IFB No. **17-63 Carlson Elementary School Gym Addition & Renovation**

RE: **ADDENDUM NO. 1**

Project: **17-63 Carlson Elementary School Gymnasium Addition & Renovations**
Project Number: IFB No. 17-63

SHEET NO.
A8.00

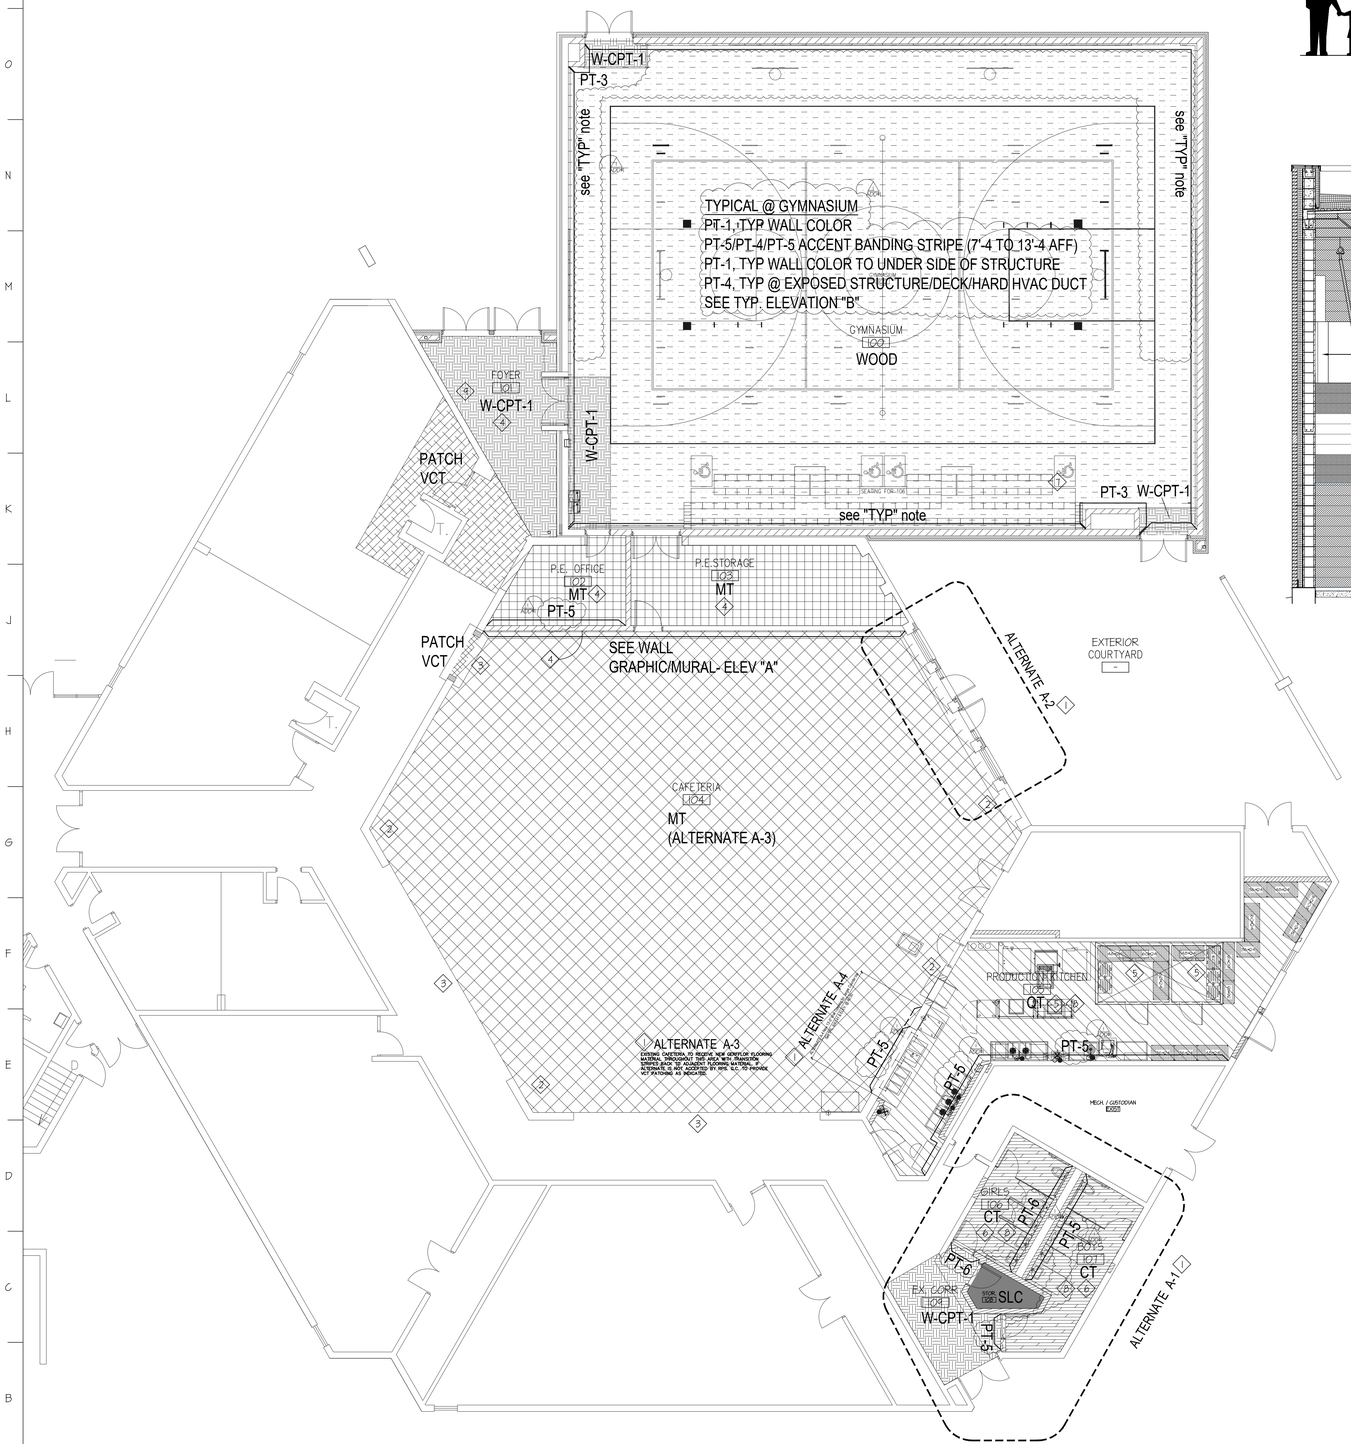
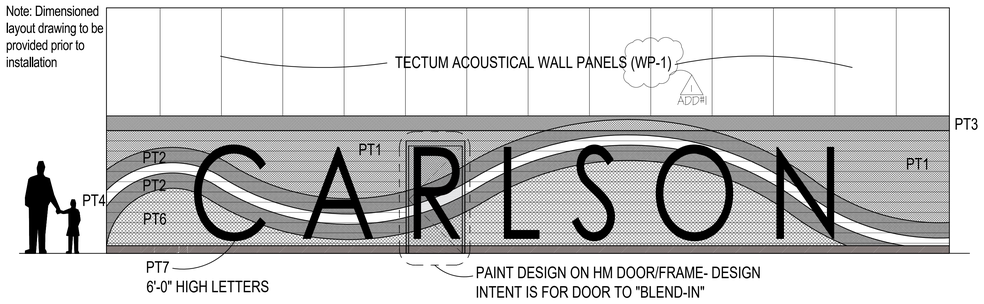
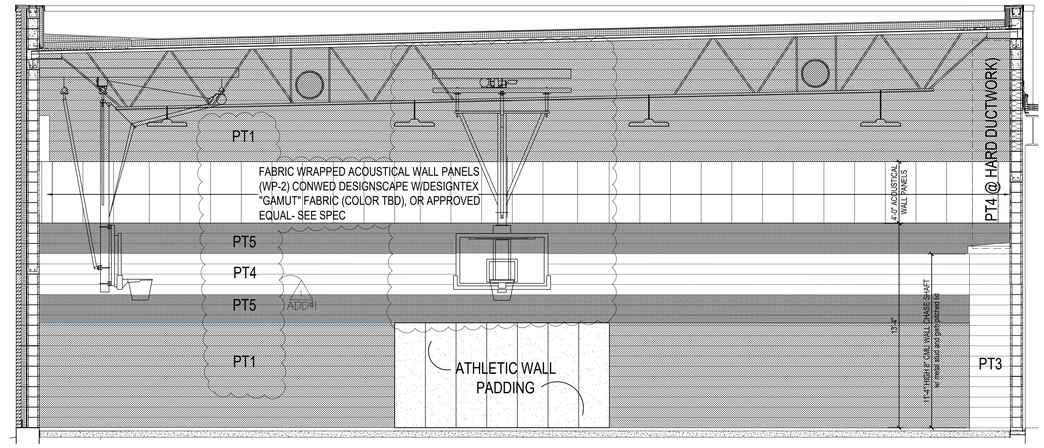
PT-1: SHERWIN WILLIAMS, SW 7015 REPOSE GRAY (TYP WALLS)
ADD#1 PT-2: NOT USED
PT-3: SHERWIN WILLIAMS, SW 7019 GAUNTLET GRAY (ACCENT 2/HM FRAMES)
PT-4: SHERWIN WILLIAMS, SW 7757 HIGH REFLECTIVE WHITE (ACCENT 3/MTL DECK/JOISTS)
PT-5: SHERWIN WILLIAMS, SW 6804 DIGNITY BLUE (ACCENT 4)
PT-6: SHERWIN WILLIAMS, SW 6381 ANJOU PEAR (ACCENT 5)
PT-7: SHERWIN WILLIAMS, SW 7069 IRON ORE (ACCENT 6)

HAGNEY ARCHITECTS LLC	1 Hour Fire Rating Assembly (P.E. Storage Room 103)	Not to Scale	DATE 07-07-2017	SHEET NO. SU-1
	Carlson Elementarty School		PROJECT NO. C1824

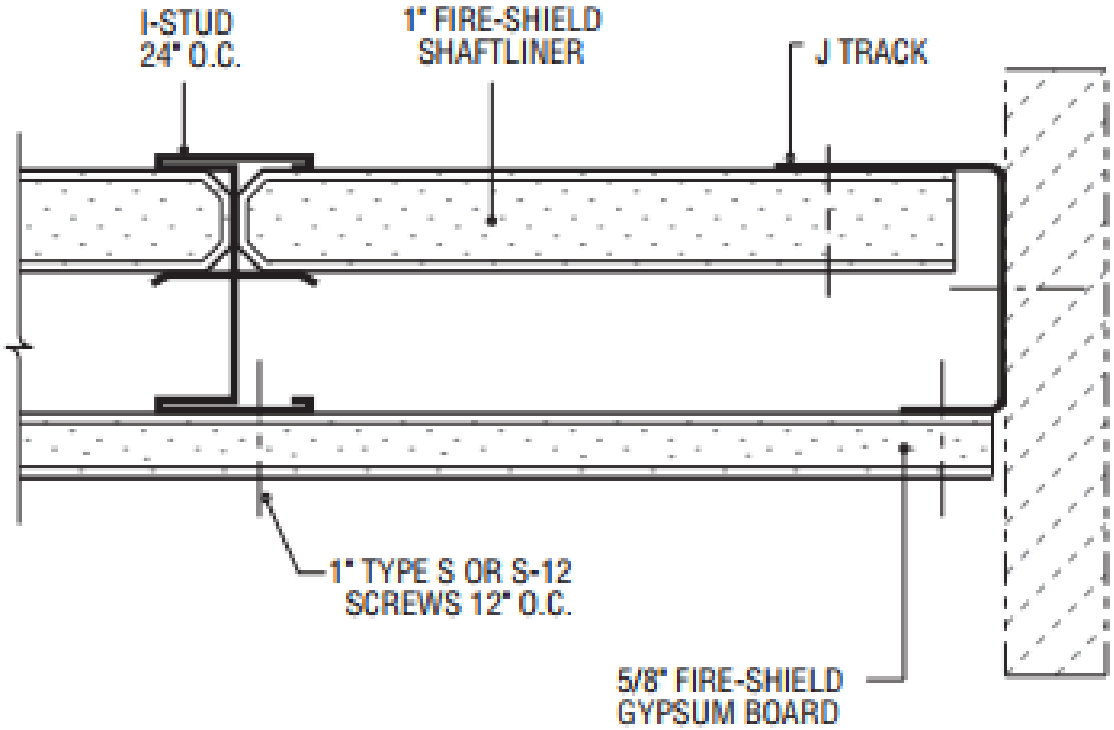
Sheet A6.00 First Floor Reflective Ceiling plan.
P.E. Storage Room 103 Add the following:
Note the following:

a) Existing ceiling ELEV is at +16'-0"+/- AFF.
b) Existing acoustical ceiling tile is glued to the underside of suspended GWB ceiling material.
c) We will add a (1) Rated suspended ceiling assembly to the underside of this existing system
d) Refer to existing Carlson School Drawings sheet 12/27 & 15/27 for reference
e) Provide 6 " I- Stud @ 24" O.C., 1" Fire-Shield Shaft Liner, J Track, 5/8" Fire Shield GWB Assembly (Refer to SU-1 Dated 07-07-2017

SHEET NO. E2.10

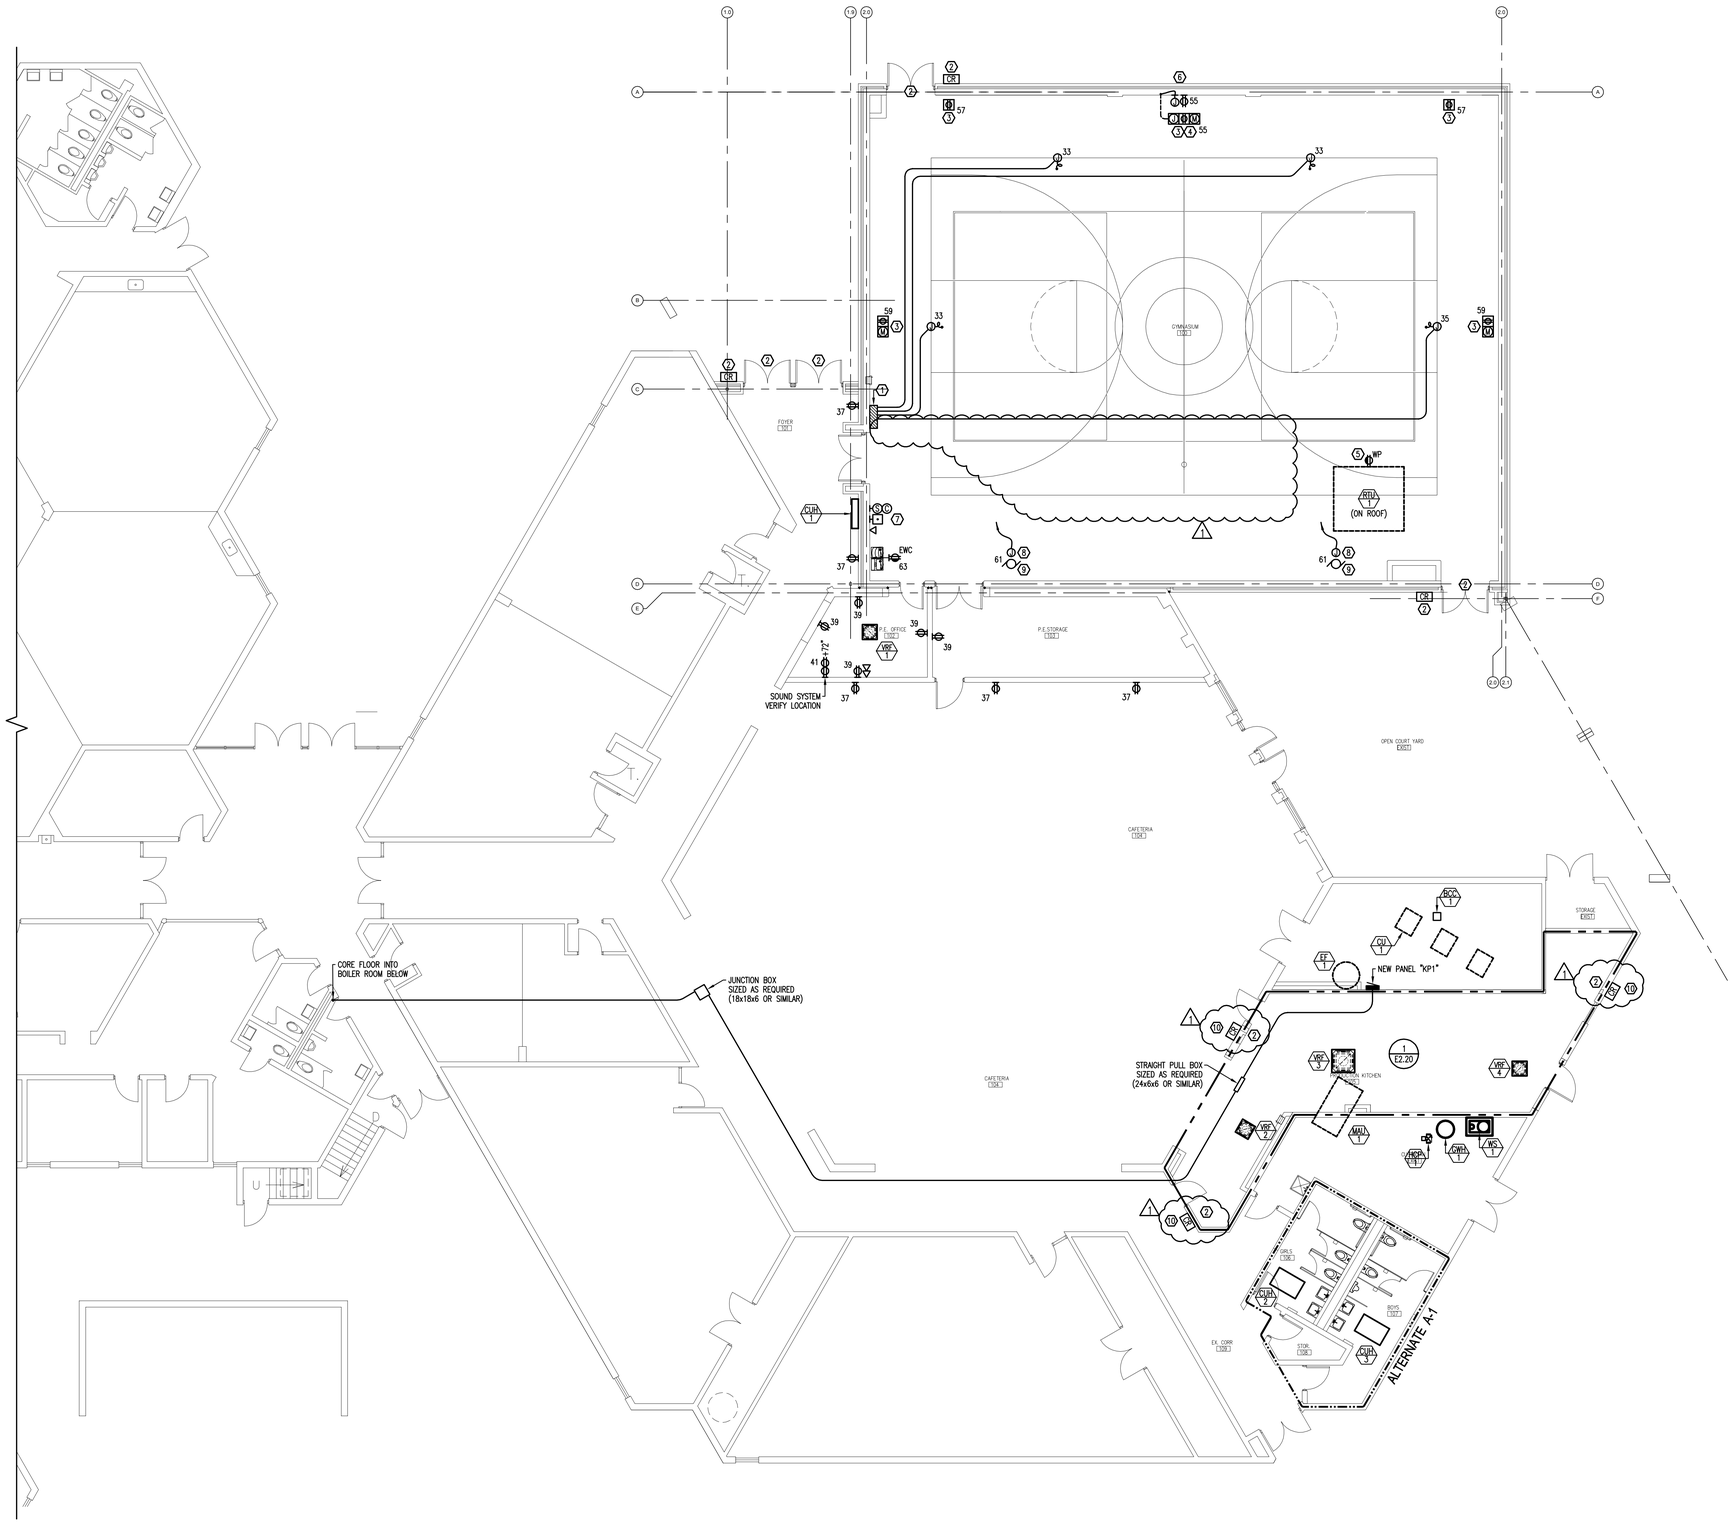
The drawing E2.10 shows electrical pigtails (ref # 33, 35) at 6 locations, which I'm assuming (ref #'s 33 and 35 are not listed on the drawing as to what they are for, just shows they come from the same wall 6 gang switches) are for the basketball backstops, however all other drawings only show 4 backstops (2 main court and two side court backstops on the North side wall.)

1. Sheet E2.10 Revised as Follows:
   a. Eliminate conduit, boxes and wiring to backboards on south side of gym.
   b. Add security conduit and back boxes at exterior Kitchen door.
   c. Add security service mounted raceway and boxes at two (2) interior Kitchen doors. See Revised Sheet E2.10.

1. **Omit reference to both divider curtain and batting cages as called for in specification section 116623 Item 2.10 and 2.11**
2. **Refer OAS Lettered dated 07-07-2017 along with revised sheet E2.10. We only have 4 backstops for this project.**
3. **Omit specification section 116623 item 2.7 reference to touch panel control. As per plans we are providing key switches as indicated on E2.10 dwg.**

1. **Refer OAS Lettered dated 07-07-2017 along with revised sheet E2.10 and E5.10. addressing both items.**

SHEET NO.
E5.10

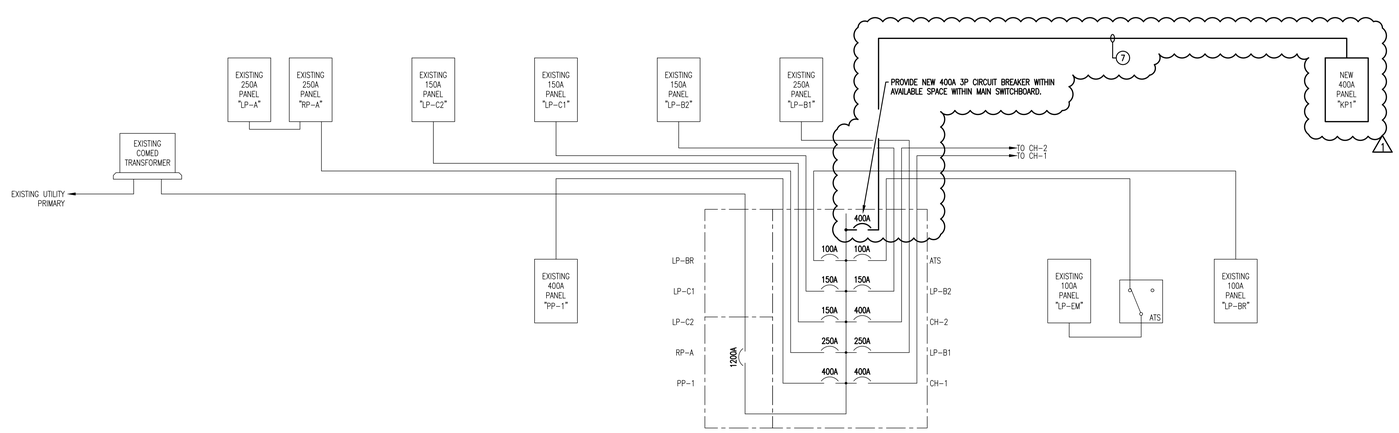
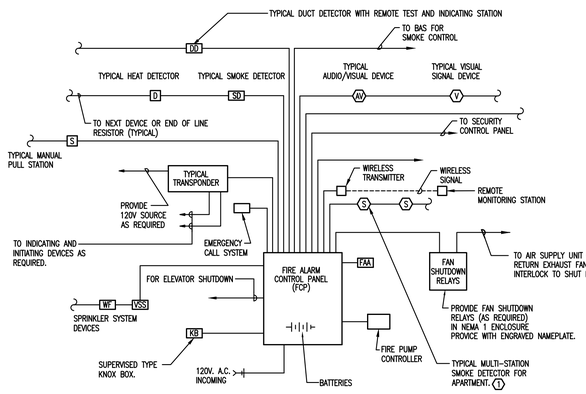
There is a new electrical panel (KP1) being added for this project.
The One-Line Riser drawing on Sheet E5.10 does not show Panel KP1 being added or how it will tie into the existing switchboard.

2. Sheet E5.10 Details & Diagrams – Electrical
   a. Revise the Single Line Diagram to indicate new Panel "KP1" being fed from a new 400A 3P circuit breaker to be provided in available space within main switchboard. See revised Sheet E5.10.

1. **Refer OAS Lettered dated 07-07-2017 along with revised sheet E5.10. addressing these items.**
